Meeting Agenda
Wilsonville Parks & Recreation Advisory Board
February 2nd, 2017
6:00 PM
Wilsonville City Hall

Memorial Park Dog Park/Community Garden Parking Lot Concept Plan

Subject: Memorial Park Dog Park/Community Garden Parking Lot

DATE: February 1, 2017
 TO: Kerry Rappold and Steve Adams, City of Wilsonville
 FROM: Scott Mansur, P.E. Jordin Kelly, EIT
 SUBJECT: Memorial Park Transportation Study

CONCEPT 3

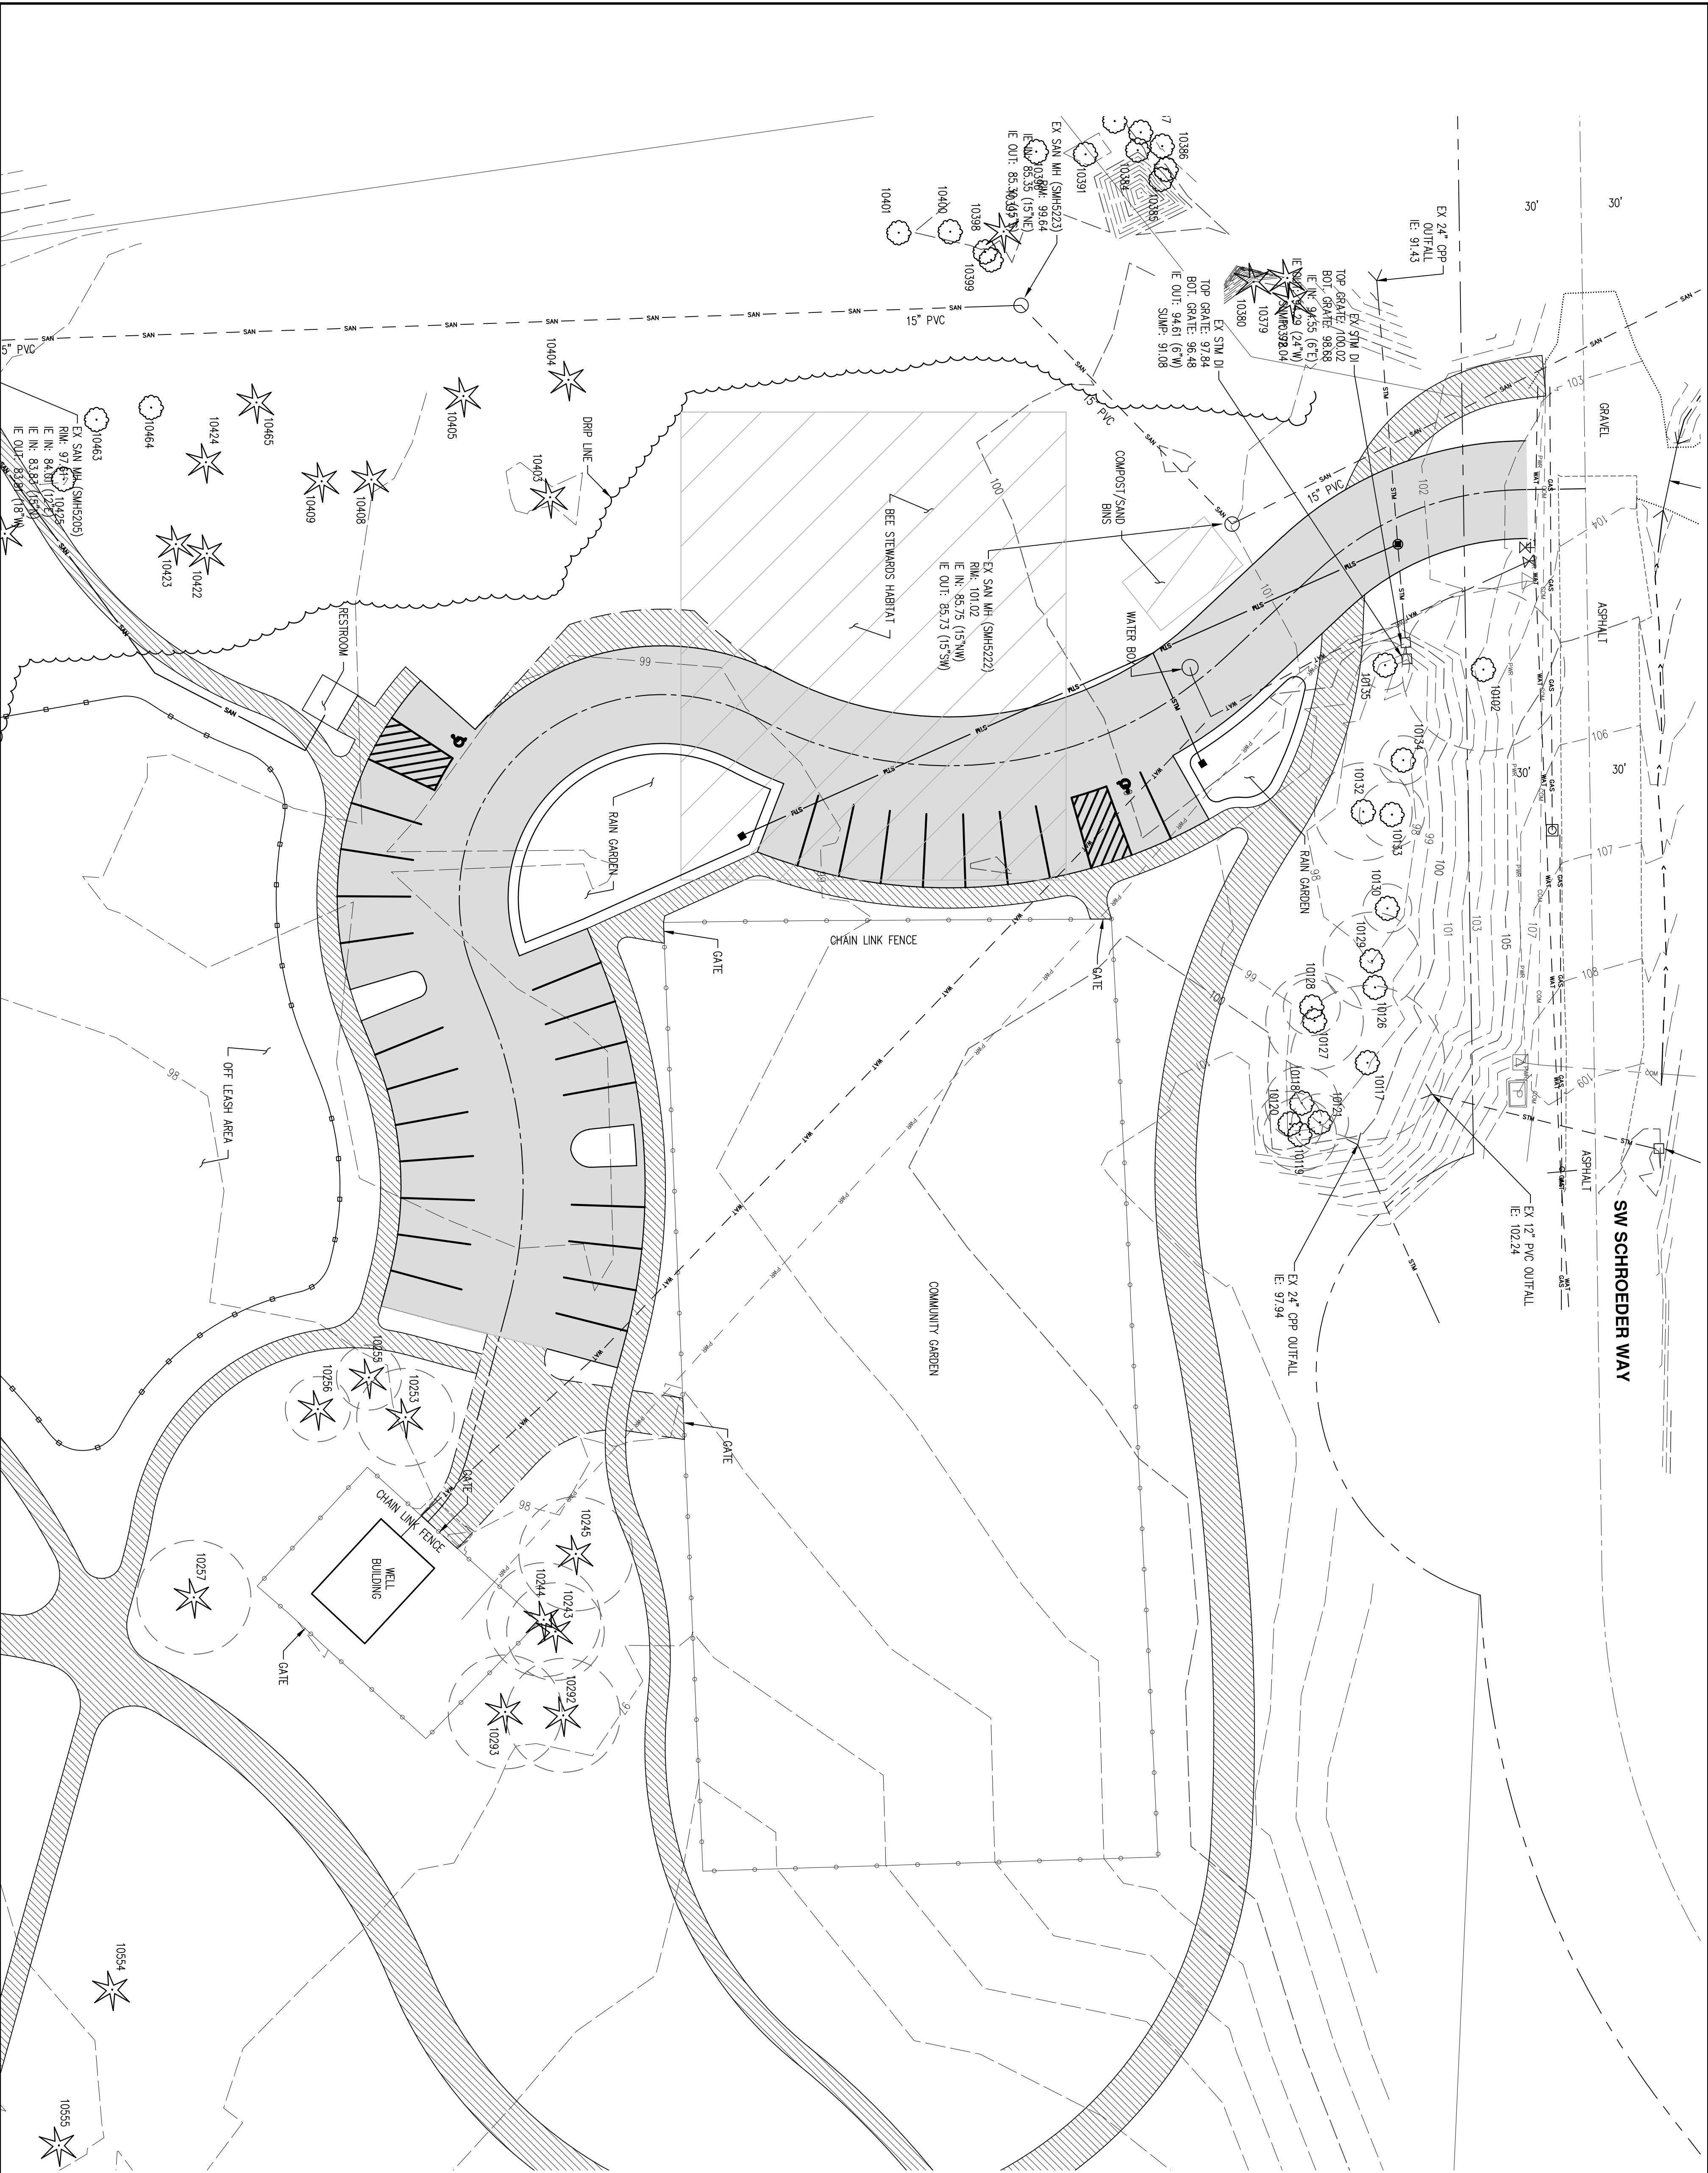
1. Questioned the reasoning behind making any changes to the current dog park when it is already successful and taxpayer money could be spent elsewhere. Also, expressed concerns about potential increase in traffic. Suggested moving the parking area to Kolbe Lane, which would impact fewer houses.

- iv. Citizen Input: Edward Pothetes (of 7475 SW Schroeder Way)
 1. Expressed concern about traffic. Believes many people do not currently follow the speed limit so an increase in traffic could be dangerous.

- v. Citizen Input: Scott Starr
 1. In an effort to explore other options than the Rose Lane/Schroeder Way intersection, Mr. Starr suggested the road to the parking lot come further south off Rose Lane through City-owned property east of the garden and proposed parking lot.

2. Mentioned that DKS, who performed the traffic study, was also contracted to study traffic for the I-5 interchange at Wilsonville Road.
- vi. Board unanimously preferred Concept #3, with request for one other option showing parking lot access off of Rose Lane. Asked if another letter could go out to the property owners in the area for their feedback.

The applicant’s preferred site plan, Concept 3, was reviewed to evaluate site access and internal circulation for vehicles, as well as pedestrian and bicycle connections. The site plan is provided in the appendix.

The proposed Memorial Park reconfiguration would utilize the existing access off of SW Schroeder Way. Based on the site plan, the proposed facility’s internal roadway network provides adequate circulation into and out of the development.

The existing configuration and proximity of the SW Wilsonville Road/SW Rose Lane and SW Rose Lane/SW Schroeder Way study intersections is not ideal for motor vehicle sight distance lines and safety. Since SW Rose Lane is a local street, the City of Wilsonville’s Transportation System Plan does not provide access spacing standards, however the City’s Public Works Standards do require a minimum 100 feet of space (curb face to driveway) from the nearest intersection for commercial developments (which this use is somewhat similar to). Presently Schroeder Way is approximately 45 feet from SW Wilsonville Road. If the City deems this Public Works Standard is applicable for the SW Schroeder Way approach, a variance to the standard may be required. However, SW Schroeder Way is also classified as a local street and as such, motor vehicle volumes and speeds are expected to be low through the atypical geometry of the SW Rose Lane/SW Schroeder Way intersection.

The low traffic volumes and surrounding mature trees indicate that increasing the spacing between this intersection and the SW Wilsonville Road/SW Rose Lane intersection would not be supported due to the high costs required to increase the spacing. However, it is recommended that the City consider improving intersection sight distance triangles by modifying the alignment of the approach angle of SW Schroeder Way to be perpendicular to SW Rose Lane as shown in the figure to the right. Vegetation

control (trimming) should be reviewed in order to improve sight distance – for existing and future conditions.

The site features sidewalks along the proposed site that connects to the reconfigured community garden and the relocated dog park. Added sidewalks are recommended to connect the site to the bicycle and pedestrian bridge that provides an access to SW Wilsonville Road via SW Kolbe Lane.

It is recommended to provide pedestrian and bicycle wayfinding signage at the entrance of SW Kolbe Lane that identifies this connection as providing the main bicycle and pedestrian access to the community gardens and the relocated dog park.

Since the relocated dog park and community garden is approximately 3 acres in size, the 33 parking stalls shown in the preliminary site plan meets the estimated parking demand for the relocated dog park and reconfigured community gardens.

Staff recommends the selection of Concept 3 with access from Schroeder Way. Due to the impacts listed above for access from Rose Lane, Concept 3 offers a better configuration and layout for the parking lot and has the least impact to surrounding areas. It is also the least costly option. Access from Schroeder Way is consistent with the Memorial Park Master Plan.

- If the Concept 3 site plan is chosen, it is recommended that the City consider realigning the approach angle of SW Schroeder Way to be perpendicular to SW Rose Lane.

CONCEPT 3B

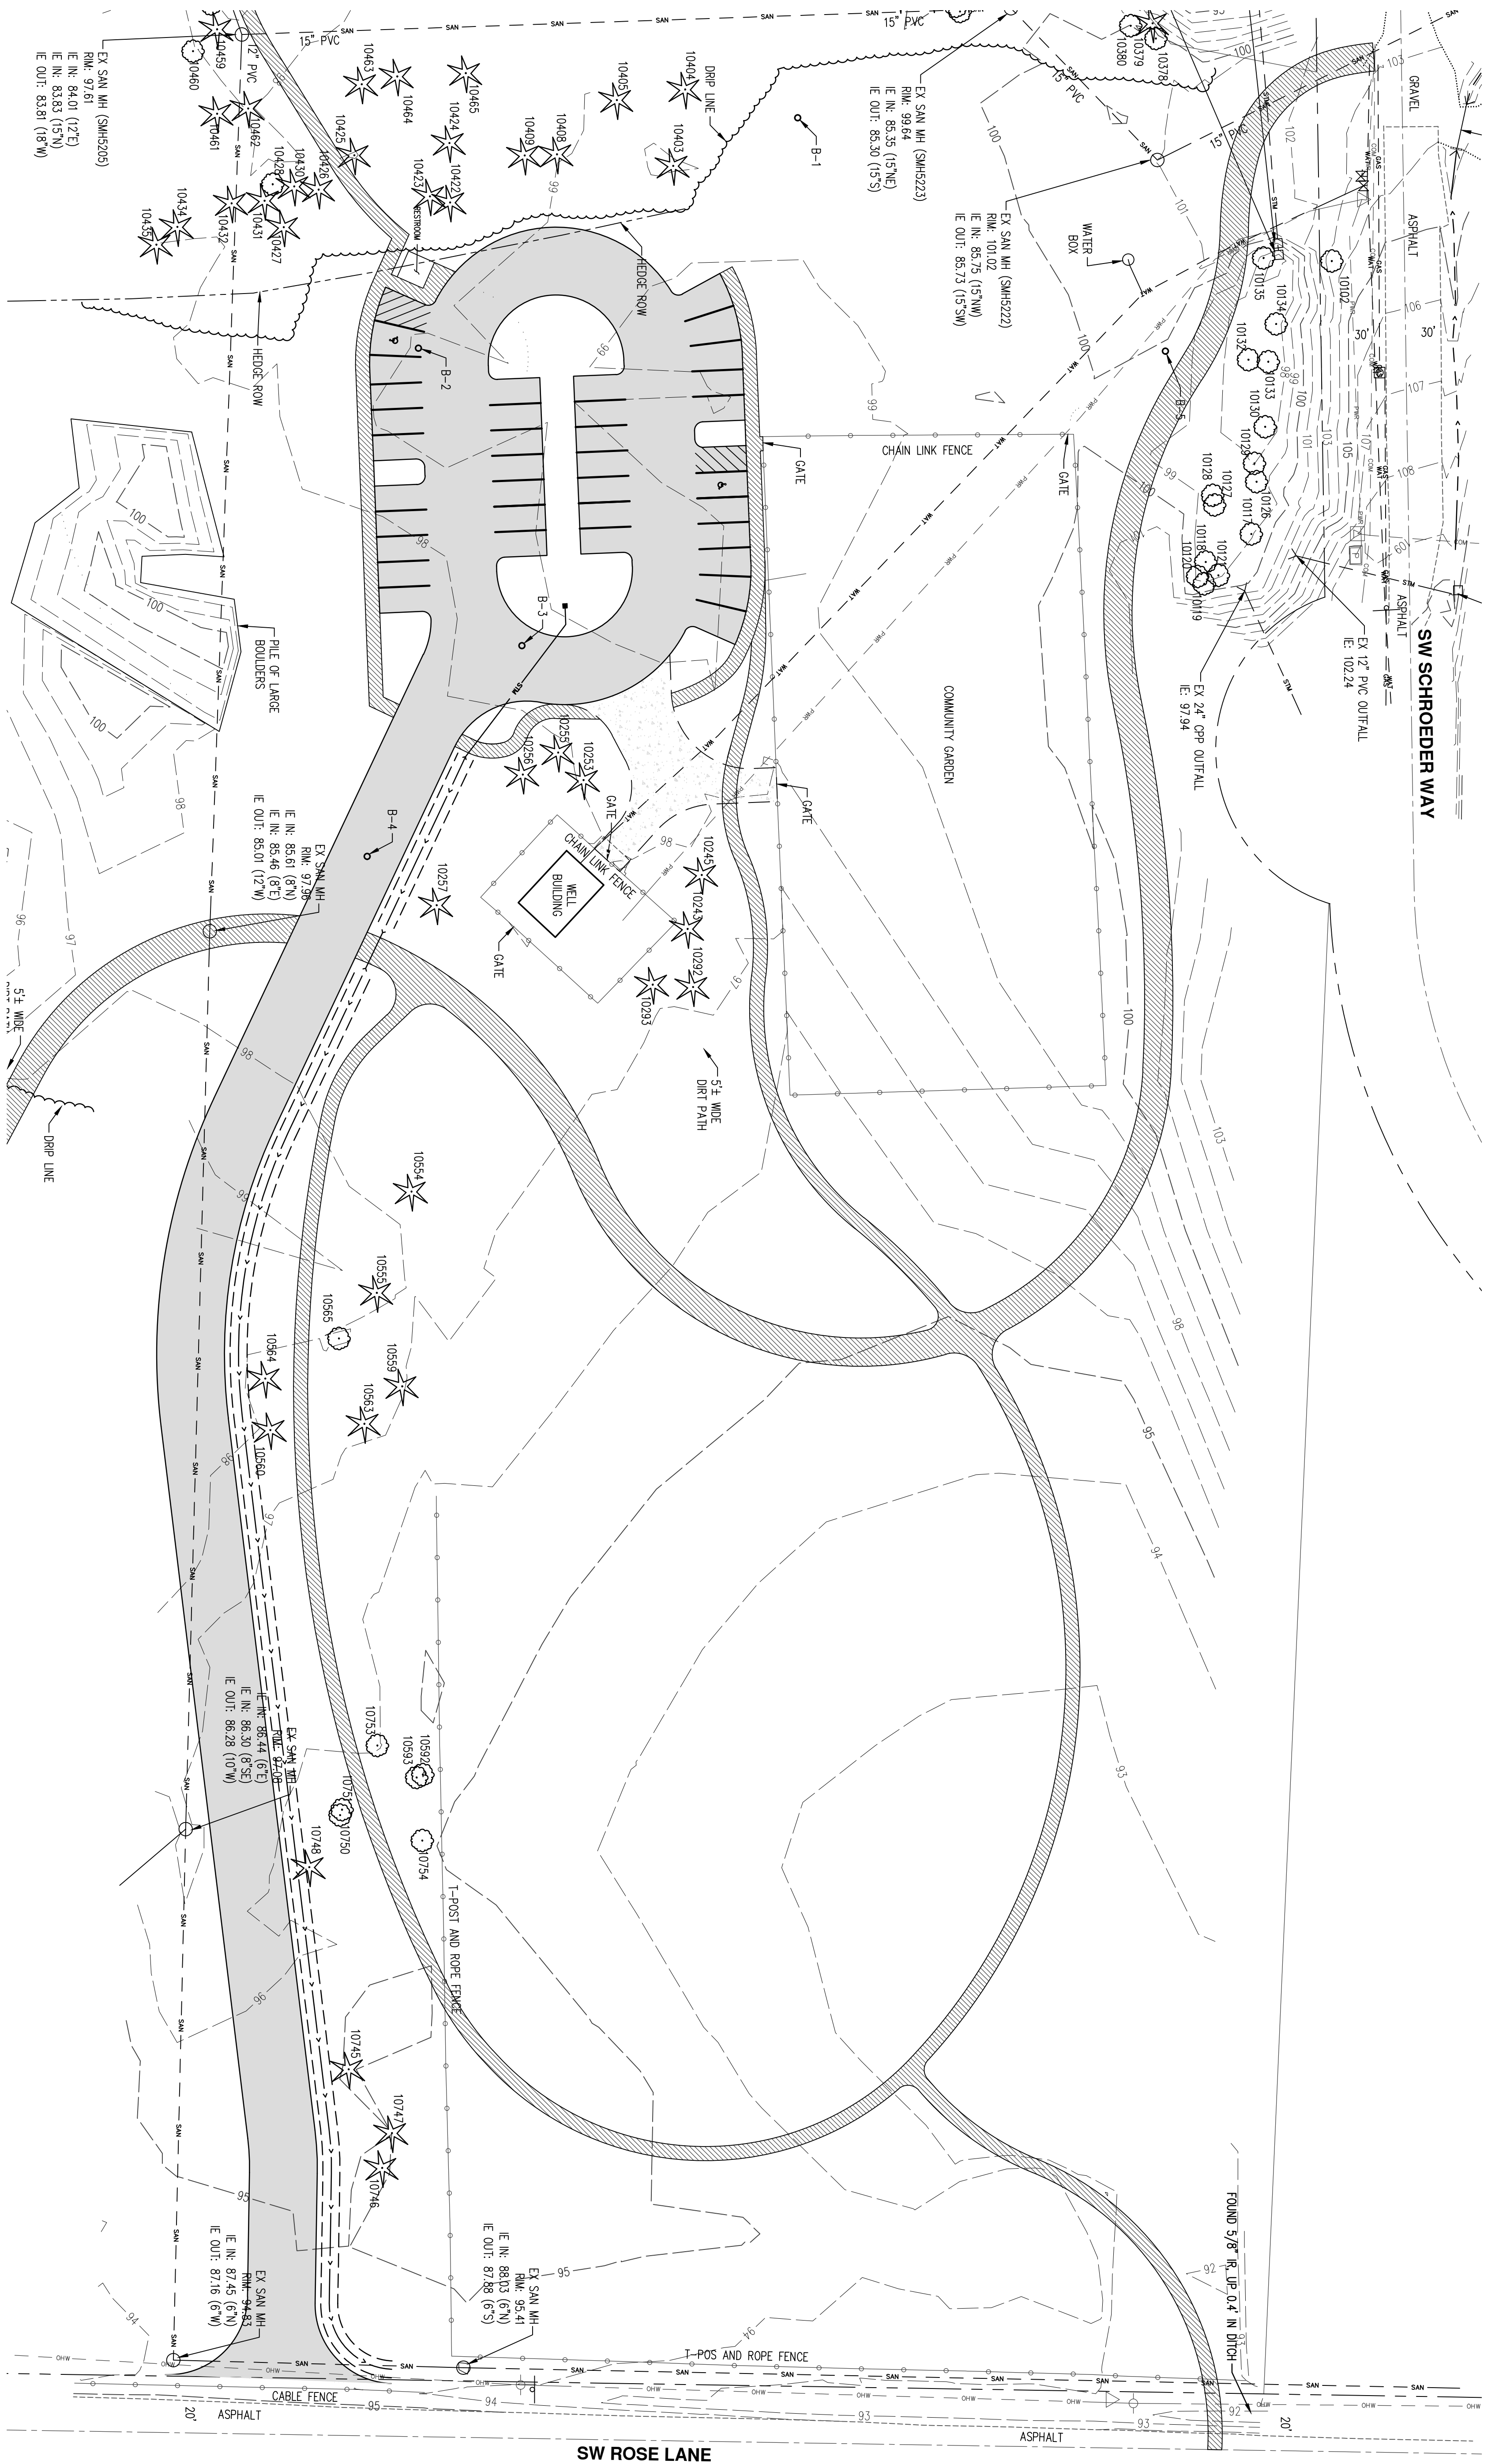
AKS Engineering analyzed the access option from Rose Lane which would require constructing a new road. This option has several constraints that need to be carefully considered by the Parks and Recreation Advisory Board. The road from Rose Lane would be built on soils that currently have significant drainage problems and the area floods several times a year. As a result, this option would require extensive soil mitigation efforts which are very expensive and would likely delay the parking lot project. Access from Rose Lane would also require reconfiguring the initial parking lot design to change the circulation pattern and orientation of the parking lot. In addition, the new access will impact the footprint for the future relocated Dog Park, increasing the cost of the dog park project which is funded by a grant.

Based on potential neighborhood impact concerns under the Concept 3 site plan, an alternative concept was considered that provides access to the park from SW Rose Lane instead of SW Schroeder Way. The following is a preliminary site plan review based on the Concept **3B** site plan provided to us (also included in the appendix). It is important to note that this site plan option will have a negligible effect on the intersection operations previously documented in this report.

The biggest difference between Concept 3 and Concept 3B is the motor vehicle access location. While Concept 3 proposes motor vehicle access to the site from SW Schroeder Way, Concept 3B proposes motor vehicle access from SW Rose Lane. Based on the Concept 3B site plan, the proposed facility's internal roadway network provides adequate circulation into and out of the development. A preliminary evaluation indicates that the proposed access off of SW Rose Lane will have adequate sight distance.

The site features walking trails along the proposed site that connects to the reconfigured community garden and the relocated dog park as well as to the bicycle and pedestrian bridge that provides an access to SW Wilsonville Road via SW Kolbe Lane. The prior recommendations to provide pedestrian and bicycle wayfinding signage at the entrance of SW Kolbe Lane that identifies this connection as providing the main bicycle and pedestrian access only is still applicable for this site plan.

The proposed 33 regular parking stalls and two ADA accessible stalls are estimated to meet the parking demand for the relocated dog park and reconfigured community gardens. In addition, bicycle parking should be provided to meet the demand of the site.

- The "Concept 3B" site plan is expected to have negligible impacts on intersection operations.
